HISTORIC AND DESIGN REVIEW COMMISSION

December 02, 2020

HDRC CASE NO:	2020-524
ADDRESS:	315 SPOFFORD
LEGAL DESCRIPTION:	NCB 1275 BLK 7 LOT 10 N 26.25 FT OF 11
ZONING:	R-5, H
CITY COUNCIL DIST.:	2
DISTRICT:	Government Hill Historic District
APPLICANT:	Rusty Beanland/Tuff Shed
OWNER:	CORDOVA HENRY E & TEENA G
TYPE OF WORK:	Garage installation
APPLICATION RECEIVED:	November 05, 2020
60-DAY REVIEW:	Not applicable due to City Council Emergency Orders
CASE MANAGER:	Huy Pham

The applicant is requesting a Certificate of Appropriateness for approval to install a 576 square feet rear accessory structure.

Hank Cordova 315 Spofford Avenue San Antonio TX 78208 Q-806986

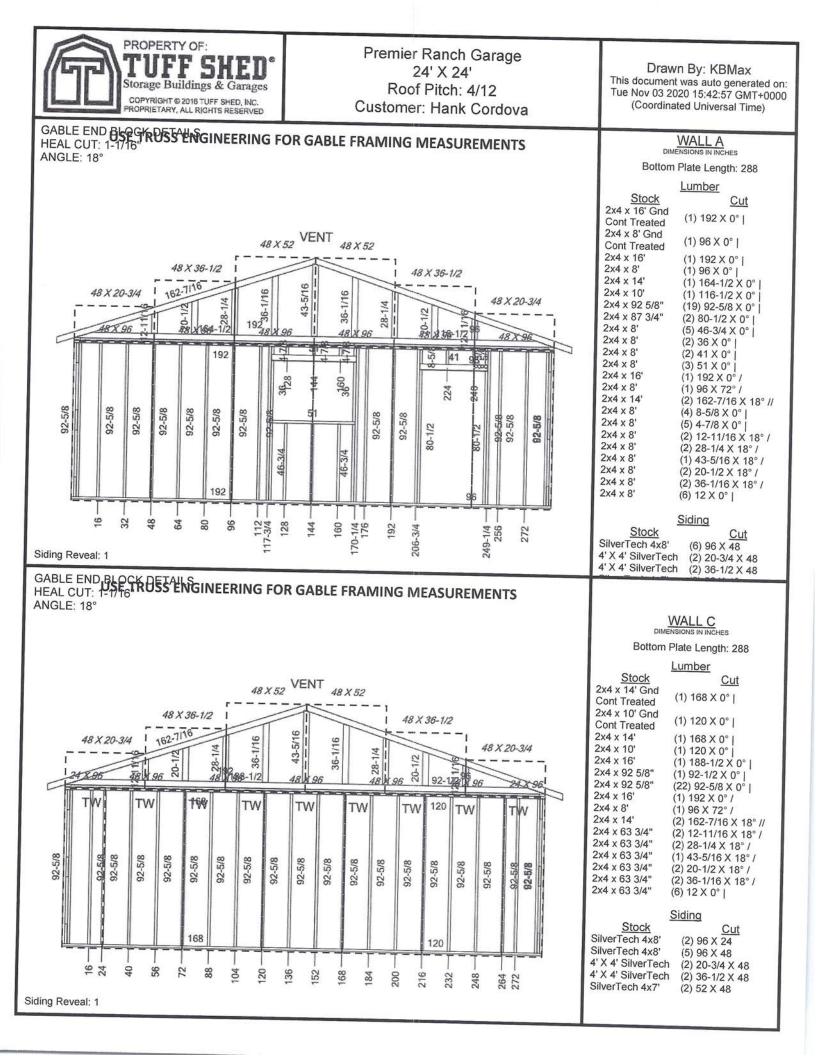
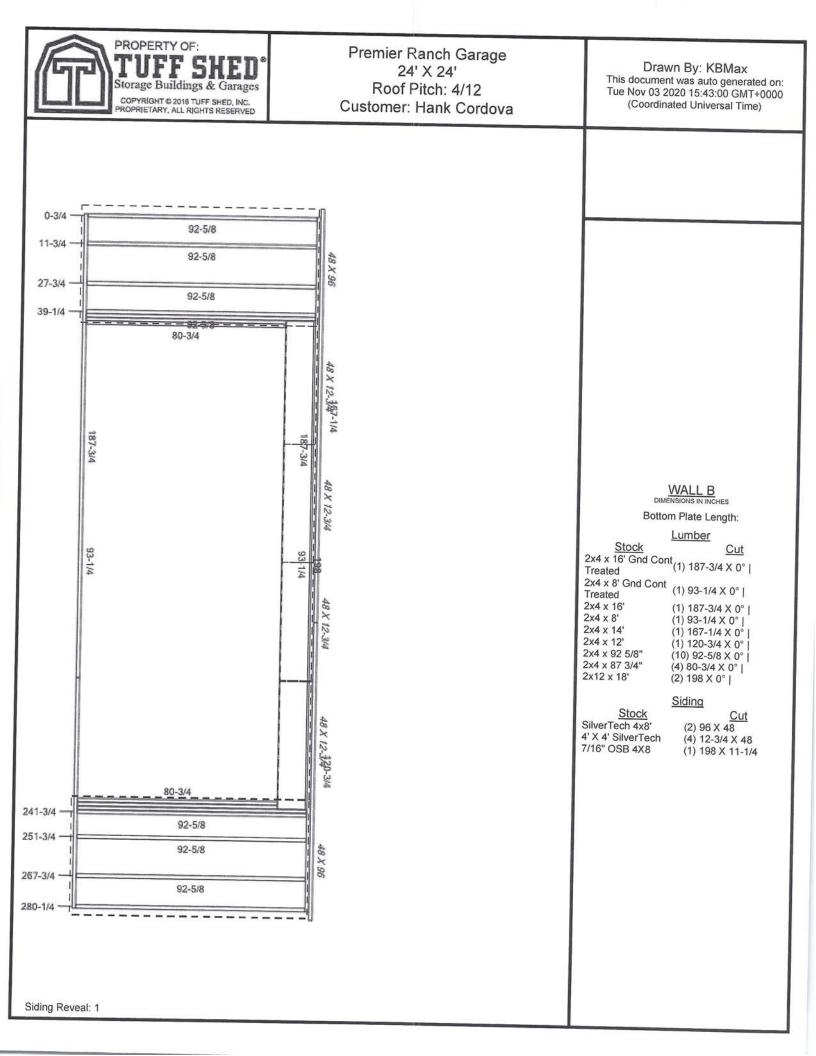
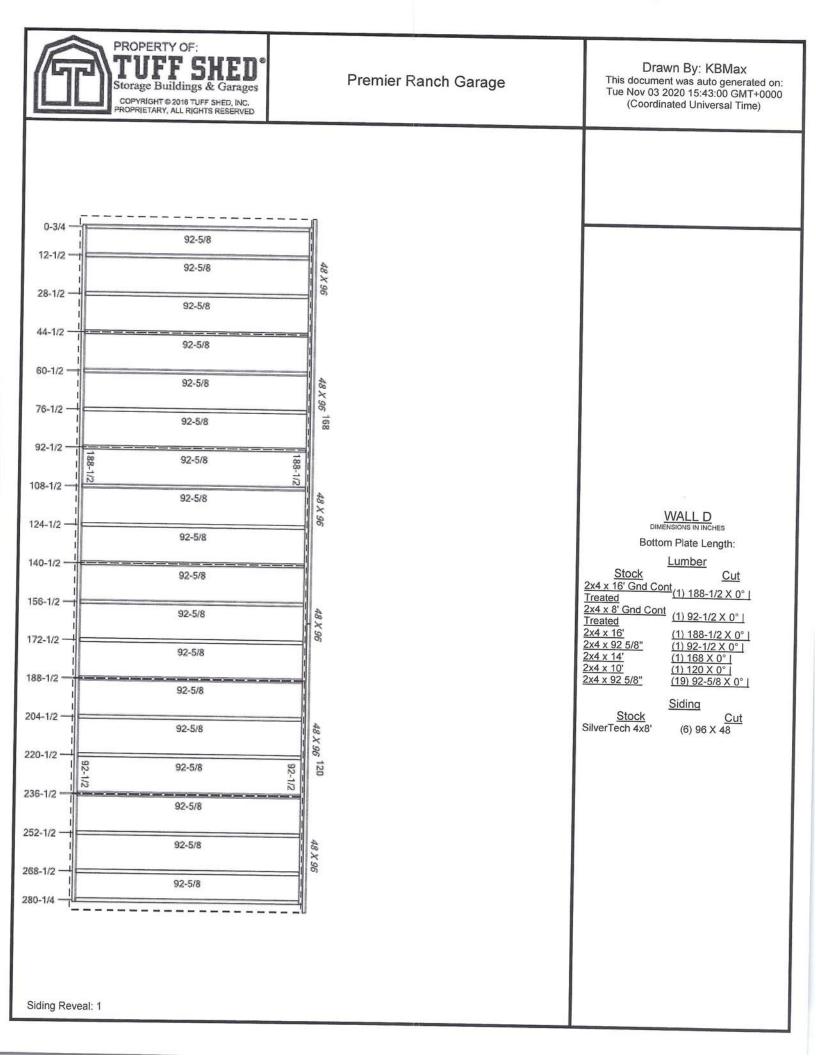
- b. REAR ACCESSORY STRUCTURE The applicant has proposed to install a 24' by 24' rear accessory structure with a concrete foundation, a 16' wide garage door, 9 transom windows and 4' x 3' sliding window, composition single roofing material, and T1-11 panel siding with SilverTech protective coating.

- e. CHARACTER The proposed accessory structure features a concrete foundation, a 16' wide garage door, 9 transom windows and 4' x 3' sliding window, composition single roofing material, and T1-11 panel siding with SilverTech protective coating. Per the Guidelines for New Construction 5.A.iii., applicants should relate new garages and outbuildings to the period of construction of the principal building on the lot through the use of complementary materials and simplified architectural details. Staff that the architectural details of the T1-11 siding profile with faux wood grain does not relate to historic character of the primary structure and should be avoided. Staff finds a board-and-batten siding profile with 10-inch width constructed with wood or smooth Hardie more appropriate.

- f. WINDOWS AND DOORS The proposed accessory structure features 9 transom windows and 4' x 3' sliding window, and a traditional six-panel door. Per the Guidelines for New Construction 5.A.iv., applicants should design window and door openings to be similar to those found on historic garages or outbuildings in the district or on the principle historic structure in terms of their spacing and proportions. Staff finds that the sliding window and transom, windows are do not relate the historic structure and should instead feature one-over-one sash windows. Additionally, final window products should adhere to the *Standard Specifications for Windows in New Construction* and should be submitted to staff prior to purchase and installation.

- g. GARAGE DOOR The proposed accessory structure features a single 16' wide garage door. Per the

Guidelines for New Construction 5.B.v., applicants should incorporate garage doors with similar proportions and materials as those traditionally found in the district. Staff finds that the garage door should be separated into two garage bays between 8-10 feet each and feature wood material in a traditional panel design.

i. That the structure features a board-and-batten siding profile with 10-inch width constructed with wood or smooth Hardie plank.

FENESTRATION- That the structure features one-over-one sash windows instead of the proposed sliding and transom windows

ii. WINDOW PRODUCT – That the final window products should adhere to the *Standard Specifications for Windows in New Construction* and should be submitted to staff prior to purchase and installation.

iii. GARAGE DOOR - That the garage door should be separated into two garage bays between 8-10 feet each and feature wood material in a traditional panel design.
